LANDMARK COMMISSION

FILE NUMBER: COA-26-000219
LOCATION: 2937 Warren Ave.
STRUCTURE: Non-Contributing
COUNCIL DISTRICT: 7
ZONING: PD-595

A Certificate of Appropriateness to construct a new main residential building on a vacant corner lot – a duplex with a rear detached two-car garage.

SHEET TITLE:
CONTEXTUAL SITE PLAN

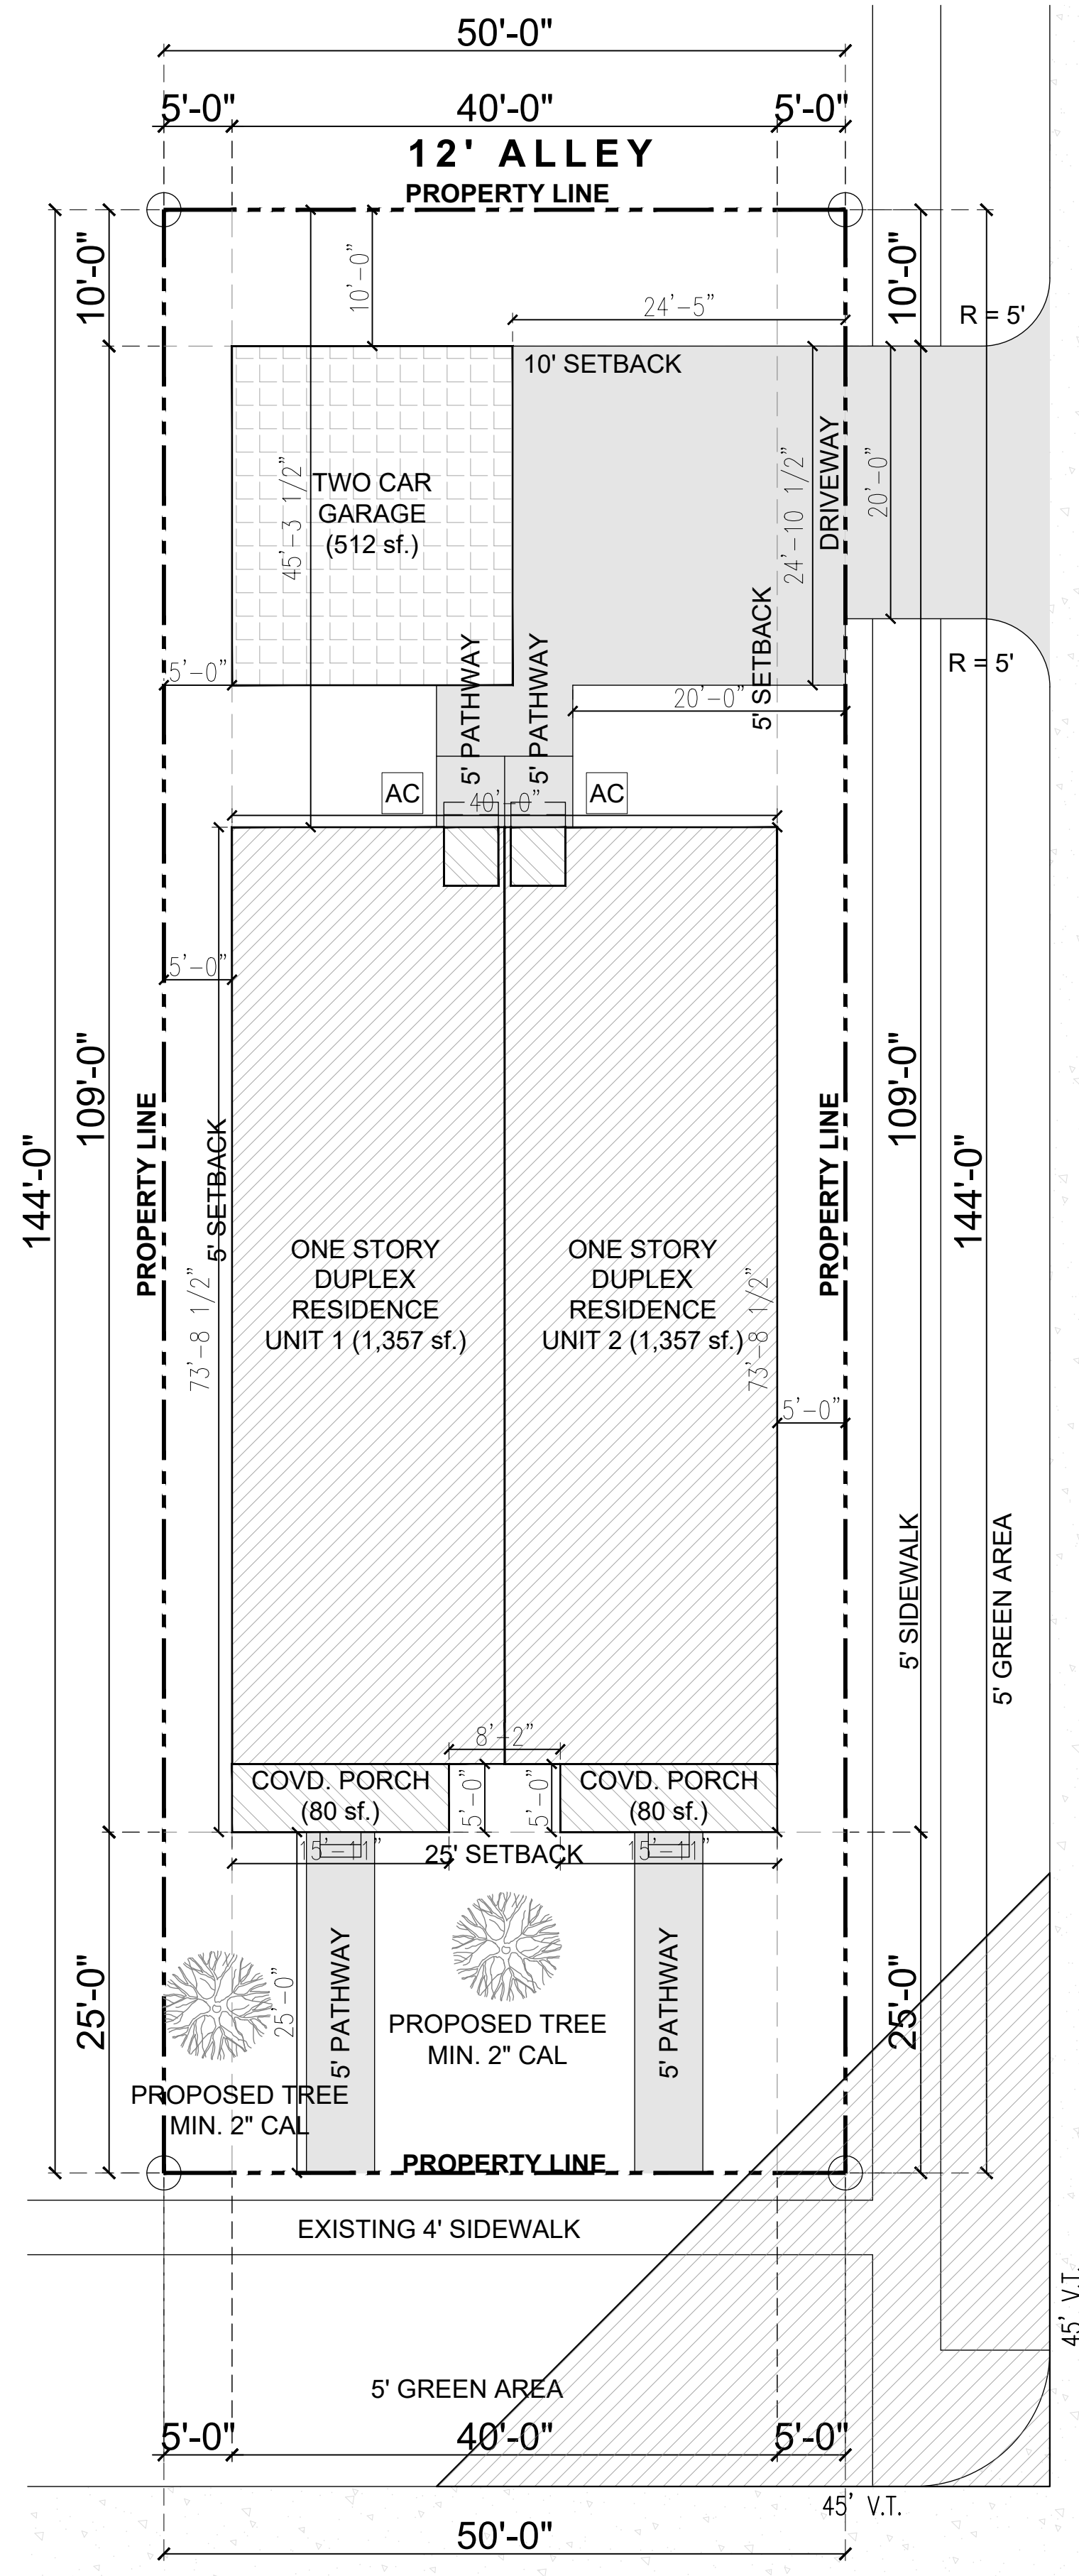
The contextual site plan and elevation sheets show that the proposed building form—one story, gabled, and porch-forward—is generally compatible with the residential character of Wheatley Place. Importantly, the architectural drawings already incorporate **gable brackets** on the **front** and **both side elevations**, reinforcing the historic porch-oriented character typical of the district.

SHEET #:
A2.01

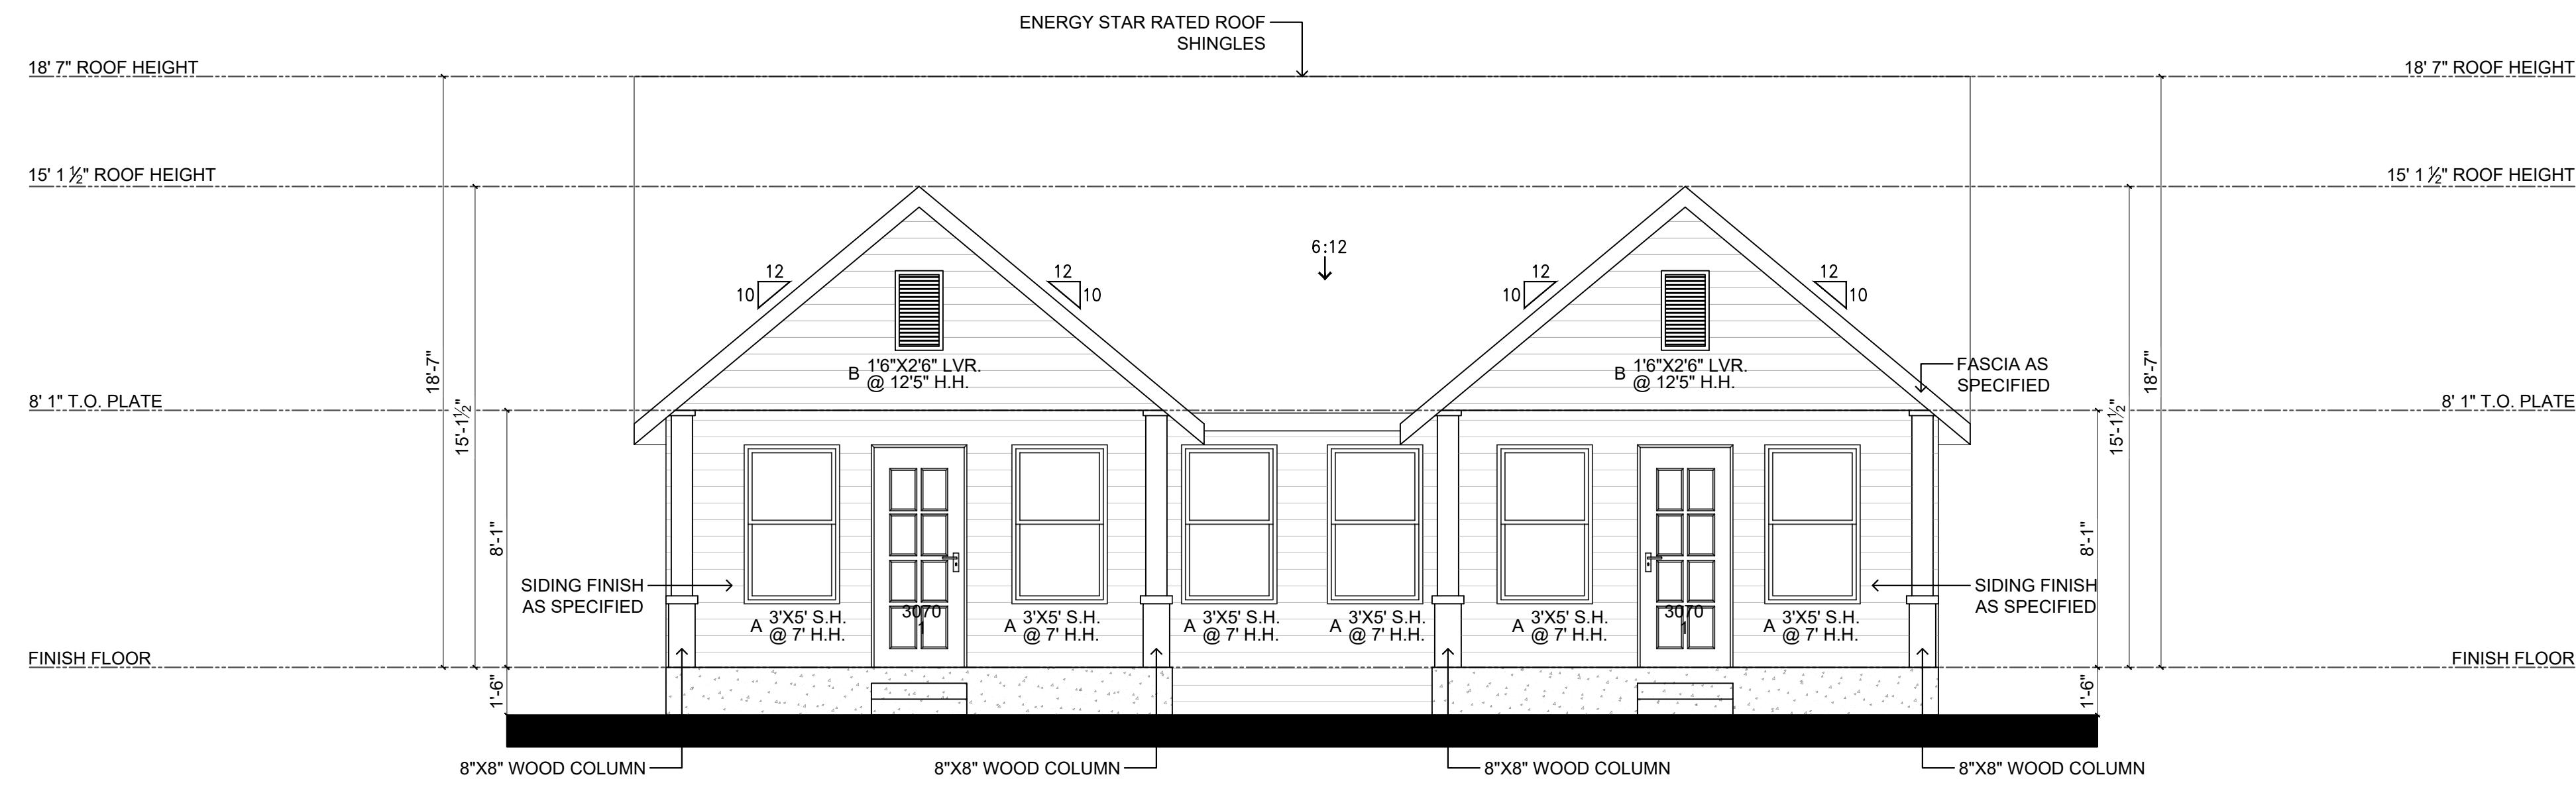
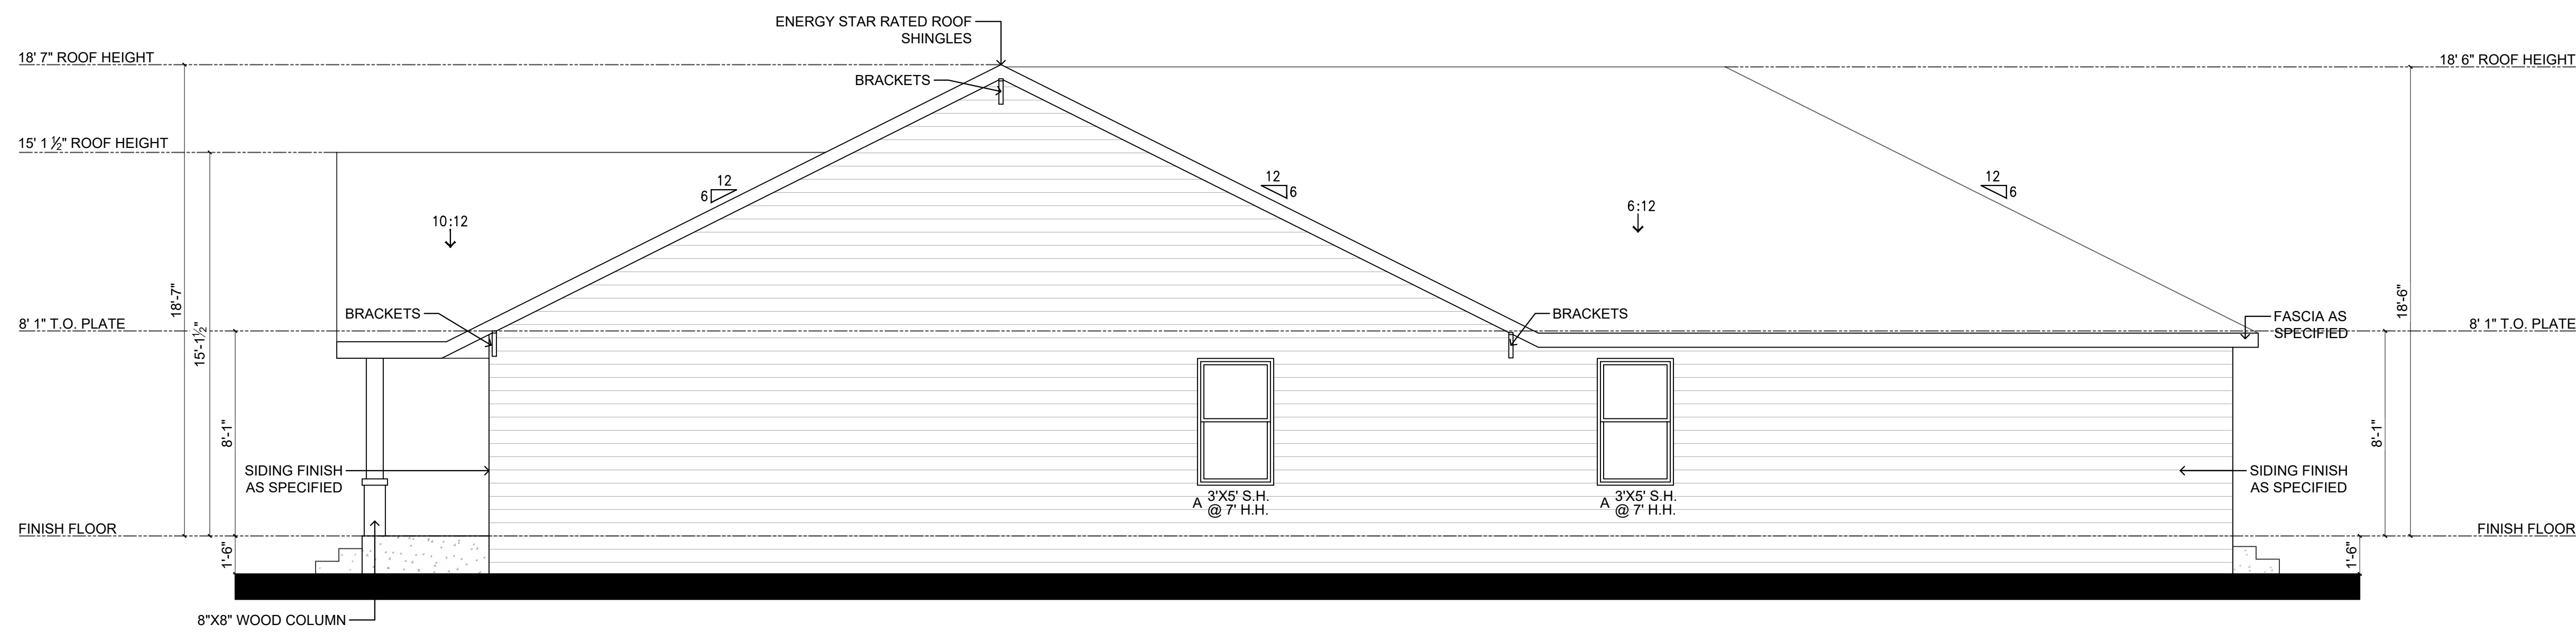
1. Add additional windows to the living room and bedrooms.
2. Add trim to the windows and to the paired windows add mullions in between.
3. Extend roof eaves to 18 inches.
4. Column bases should be brick and need to be at ground level.
5. Check the color for the siding.
6. Update material sheet.
7. Add brackets on the front façade.
8. Review the side gable(s).

Add additional windows to the living room and bedrooms

Add trim to the windows and the paired windows add millions in between. 18in roof eaves

Col. base brick need to be at ground level check the color for the siding, update material

sheet, brackets on the front facade, review the side gable
